Contract #: 04-0120F4
 Cty: SF/ALA Rte: 80 PM: 13.2/13.9
 File #: 69.25B

QUALITY ASSURANCE -- NON-CONFORMANCE REPORT

Report No: NCR-000723

Job Name: SAS Superstructure
Document No: 05.03.06-000681

Reference Description: Missed MT indication by QC on Segment 9DW Deck Panel to Diaphragm

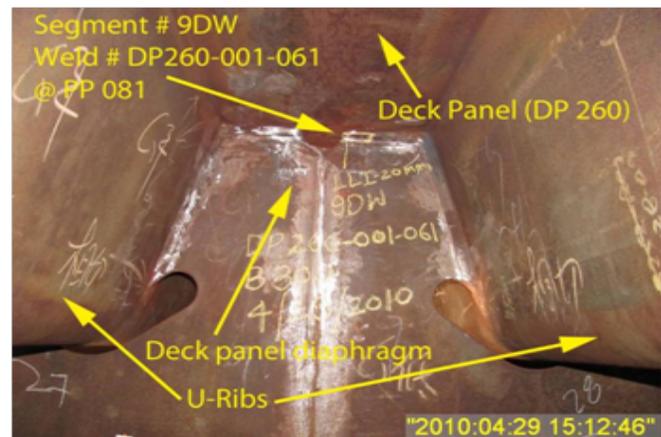
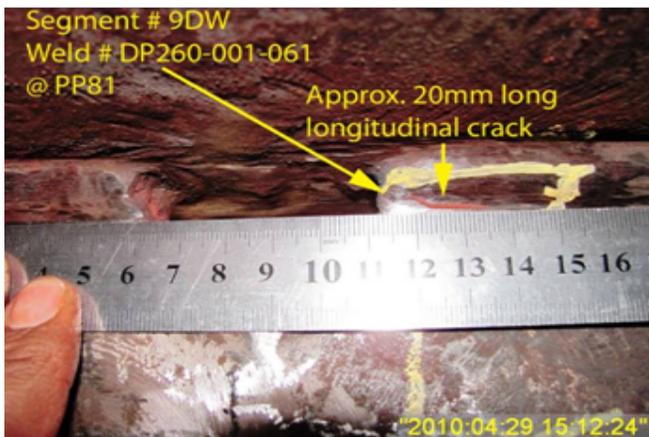
During the Quality Assurance (QA) Magnetic Particle Testing (MT) review of welds located on Segment 9DW, this QA Inspector discovered the following issue:

- One (1) Longitudinal linear crack like indication measuring approximately 20 mm in length.
- The weld is identified as DP260-001-061 @ Panel Point 081.
- The weld is a Fillet Weld T-joint joining the Deck Plate to Deck Panel Diaphragm plate.
- The plate number for Deck Plate is identified as PL307A (Non SPCM).
- Deck panel diaphragm plate is identified as X1E (Non SPCM).
- The indication is clearly marked on the material near the weld.
- OBG Segment 9DW is located at the back side of OBG Bay #14.
- The Notice of Witness Inspection Number (NWIT) is 005616. The indication is located inside the area that has been previously tested and accepted by ZPMC Quality Control (QC) personnel. Per the contract documents ZPMC's QC personnel are required to perform 100% MT inspection of this weld.

AWS D1.5 (02) Section 6.26.2 – “Welds that are subject to MT in addition to visual inspection shall have no cracks.

Reference Resolution: ZPMC has repaired the welds in question and is providing NDT documentation to show that the welds are acceptable. Based on this ZPMC requests closure of this NCR.

This proposed resolution is acceptable. The documentation received is sufficient and the Department concurs that Non-Conformance ZPMC-0686 is closed.

Reference Description: MT Indications discovered after ZPMC's NDT testing and acceptance in Segment 7CW

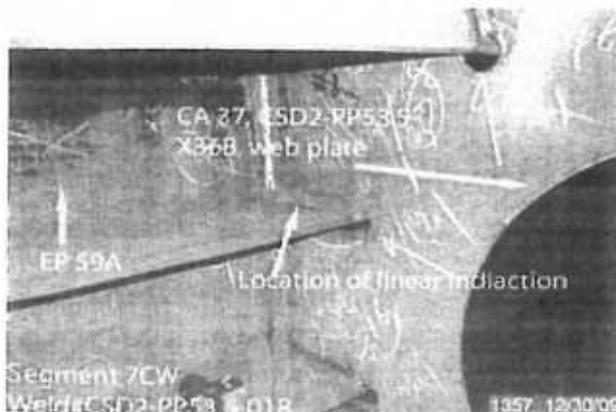
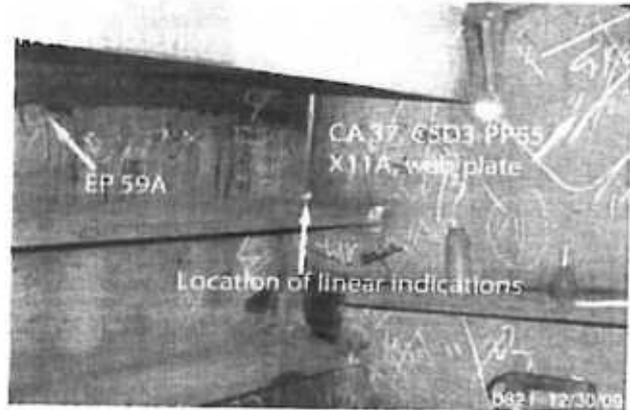
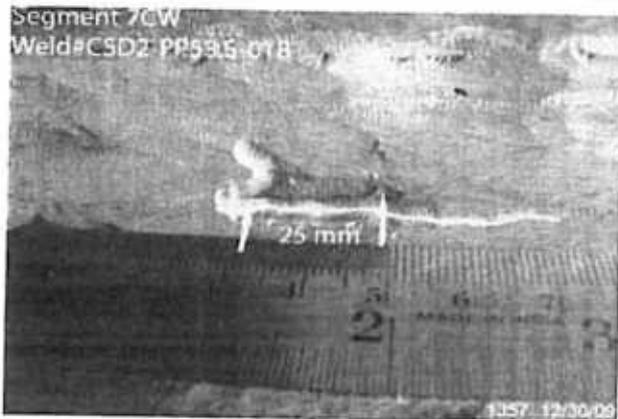
During the Quality Assurance Magnetic Particle Testing (MT) review of welds located on Segment 7CW, this Quality Assurance Inspector (QA) discovered the following issues:

- Two (2) Longitudinal linear indication measuring approximately 20mm and 25mm in length.
- The welds are identified as: CSD3-PP55-025, 026 (30 mm) and CSD2-PP53.5-018 (25 mm).
- The welds are a Fillet Weld type joining the Edge Plate (EP59A) stiffeners to Corner Assembly (CA37A) web plates.
- The OBG 7CW segment is located at in front of Blast Shop.

The Notice of Witness Inspection Number (NWIT) is 004947. The indication is located inside the area that has been previously tested and accepted by ZPMC Quality Control (QC) personnel. ZPMC's QC personnel are required to perform twenty five (25%) percent MT inspection of this weld.

AWS D1.5 (02) Section 6.26.2 – “Welds that are subject to MT in addition to visual inspection shall have no cracks.

Submit a repair procedure to the engineer for approval. Provide the ZPMC MT technician additional training and equipment to ensure these types of indications are identified in the future.

Reference Description: Missed UT indications by QC on Segment 9DE: Edge Plate to Deck Plate weld and Edge Plate Stiffener to FL3 weld

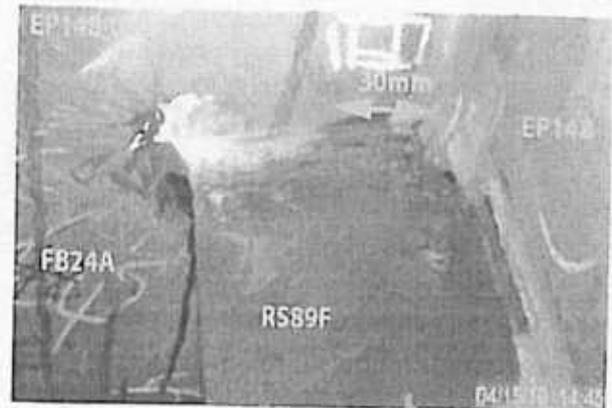
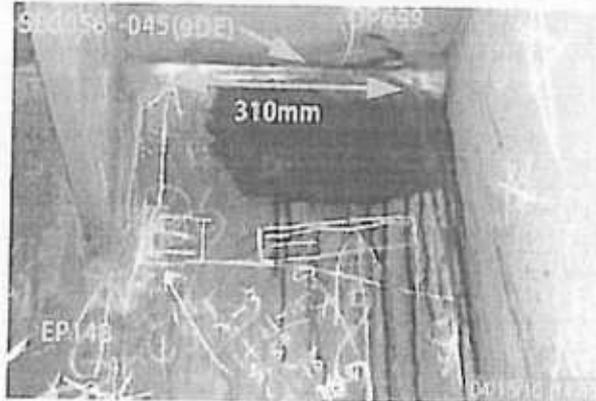
During the Quality Assurance (QA) Ultrasonic Testing (UT) review of welds located on Orthotropic Box Girder (OBG) Segment 9DE, this QA Inspector discovered the following issues:

- Two (2) longitudinal linear indications measuring approximately 310mm and 30mm in length.
- The indications dBs rating are +6 and +4.
- Material thickness is 18mm.
- The depth of the indications is approximately 11mm and 13mm.
- The welds are identified as SEG056*-045 at Panel Point (PP) PP81.5 and EP148-022 at PP 81.
- The welds are designated as Seismic Performance Critical Material (SPCM).
- The indications are clearly marked on or near the weld.
- The Y distance for the indications are 50 mm from PP81.5 and 0 mm from EP148A.
- Weld SEG056*-045 is a Complete Joint Penetration (CJP) Corner joint, joining the Edge Plate PL1336C (SPCM) to Deck Plate PL1314A (Non SPCM).
- Weld EP148-022 is a Complete Joint Penetration (CJP) "T" joint, joining the Edge Plate stiffener RS89F (Non SPCM) to FB24A plate PLX24D (SPCM).
- Segment 9DE is located outside of Paint shop.

The Notice of Witness Inspection (NWIT) No. is 005523. The indication is located in an area previously tested and accepted by ZPMC Quality Control (QC) personnel. As per the contract documents, ZPMC's QC personnel are required to perform hundred (100%) percent UT inspection of this weld.

AWS D1.5-02 Section 6; Table 6.3 specifies a class "A" indication as having a rating of 10dBs and under for material thicknesses 8mm through 20mm.

Propose a resolution for the identified non-conformance to prevent future occurrences. A response for the resolution of this issue is expected within 7 days.

Reference Description: QC Missed 2 MT Transverse Indications on Segment 9EE U-Rib Deck Diaphragm welds

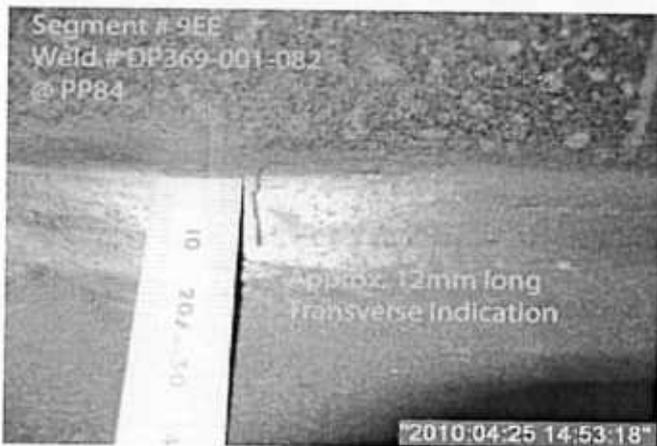
During the Quality Assurance (QA) Magnetic Particle Testing (MT) review of welds located on Segment 9EE, this QA Inspector discovered the following issues:

-One (1) Transverse linear crack like indication measuring approximately 12 mm in length.

-The weld is identified as DP369-001-082 @ Panel Point-084.

-The weld is a Fillet Weld T-joint joining the Deck Plate (DP369) to Deck panel diaphragm plate.

-One (1) Transverse linear indication measuring approximately 10 mm in length.

-Weld is a Complete Joint Penetration (CJP) Weld joining the Deck panel Diaphragm to U-Rib.

-Weld Identification number is DP477-001-137 @ Panel Point-083.

AWS D1.5 (02) Section 6.26.2 – “Welds that are subject to MT in addition to visual inspection shall have no cracks

Propose a resolution for the identified non-conformance with revised procedures to prevent future occurrences. A response for the resolution of this issue is expected within 7 days.

Reference Description: Missed MT Transverse Indication by QC on Segment 9EE Floor Beam Flange to Deck Diaphragm Weld

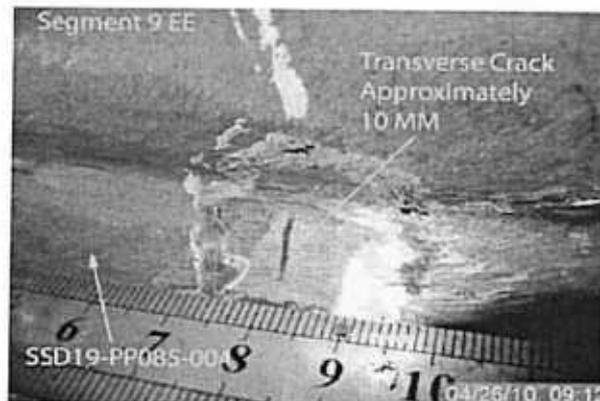
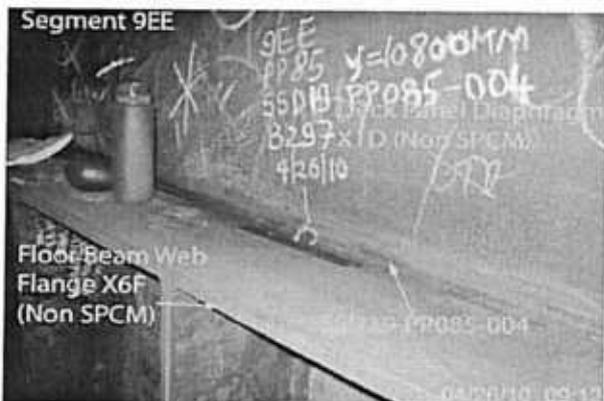
During the Quality Assurance (QA) Magnetic Particle Testing (MT) review of welds located on Segment 9EE, this QA Inspector discovered the following issues:

- One (1) transverse crack measuring approximately 10mm in length in the fillet weld joining the Deck Panel Diaphragm (X1D) to Floor Beam Web Flange (X6F) at panel point 85.
- The Y location is 10800mm from the termination of the weld on the crossbeam side.
- The indication is clearly marked near the weld.
- The weld is identified as: SSD19-PP085-004.
- OBG segment 9EE is located north of the blast shop.
- The Notice of Witness Inspection Number (NWIT) is 005583. The indication is located within the area that has been previously tested and accepted by ZPMC Quality Control (QC) personnel.

AWS D1.5 (02) Section 6.26.2 – “Welds that are subject to MT in addition to visual inspection shall have no cracks.

Propose a resolution for the identified non-conformance with revised procedures to prevent future occurrences. A response for the resolution of this issue is expected within 7 days.

Reference Description: Missed MT indication by QC on Segment 9DW Deck Panel to Diaphragm

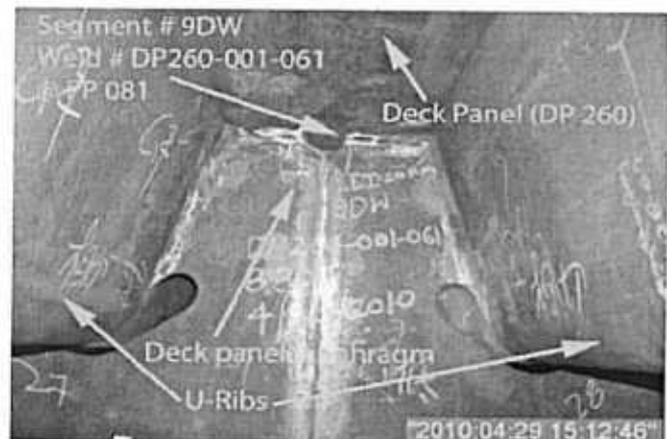
During the Quality Assurance (QA) Magnetic Particle Testing (MT) review of welds located on Segment 9DW, this QA Inspector discovered the following issue:

- One (1) Longitudinal linear crack like indication measuring approximately 20 mm in length.
- The weld is identified as DP260-001-061 @ Panel Point 081.
- The weld is a Fillet Weld T-joint joining the Deck Plate to Deck Panel Diaphragm plate.
- The plate number for Deck Plate is identified as PL307A (Non SPCM).
- Deck panel diaphragm plate is identified as X1E (Non SPCM).
- The indication is clearly marked on the material near the weld.
- OBG Segment 9DW is located at the back side of OBG Bay #14.
- The Notice of Witness Inspection Number (NWIT) is 005616. The indication is located inside the area that has been previously tested and accepted by ZPMC Quality Control (QC) personnel. Per the contract documents ZPMC's QC personnel are required to perform 100% MT inspection of this weld.

AWS D1.5 (02) Section 6.26.2 – “Welds that are subject to MT in addition to visual inspection shall have no cracks.

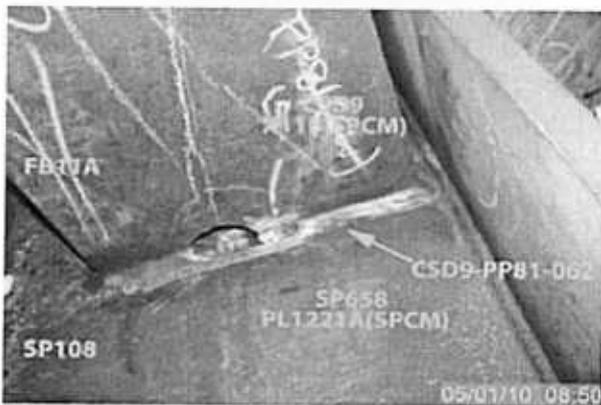
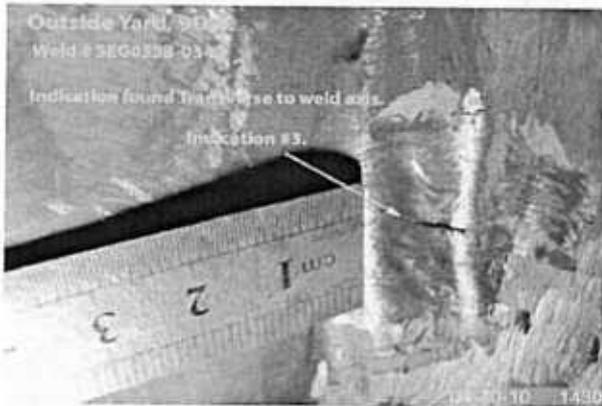
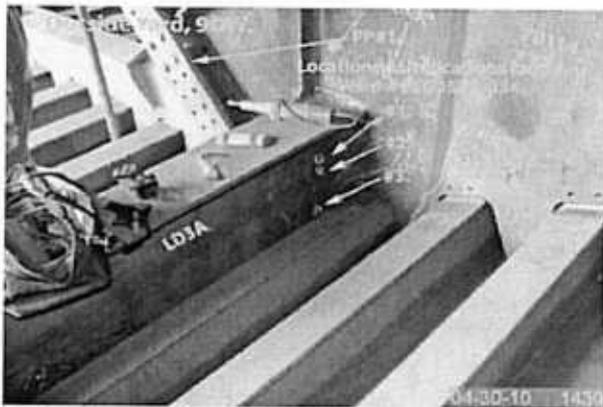
On April 30, 2010:

- Three transverse linear indications, one measuring approximately 9mm and two indications measuring approximately 5mm in length at Longitudinal Diaphragm (LD) LD3A to Floor beam (FB) FB11A.
- Weld is identified as SEG055B-034 and designated as a Fracture Critical Weld (FCW).
- The weld is a 14mm Complete Joint Penetration (CJP) T-joint joining LD 3A shear plate identified as X39B to FB web plate identified as X47C (Seismic Performance Critical Material SPCM).
- The indications are clearly marked on the material.

On May 1, 2010:

- One (1) Longitudinal linear indication measuring approximately 18mm in length.
- The Y location is 7mm from the cope hole.
- The indication is clearly marked on the material near the weld.
- The weld is identified as: CSD9-PP81-062.
- The weld is designated as Seismic Performance Critical Member (SPCM).
- The weld is located at PP81 (Counter Weight Side).
- The weld is a Fillet Weld T-joint joining the Corner Assembly Diaphragm identified as X11B (SPCM) to Side Plate identified as SP658 (SPCM).
- OBG segment 9DW is located west of Bay #14.
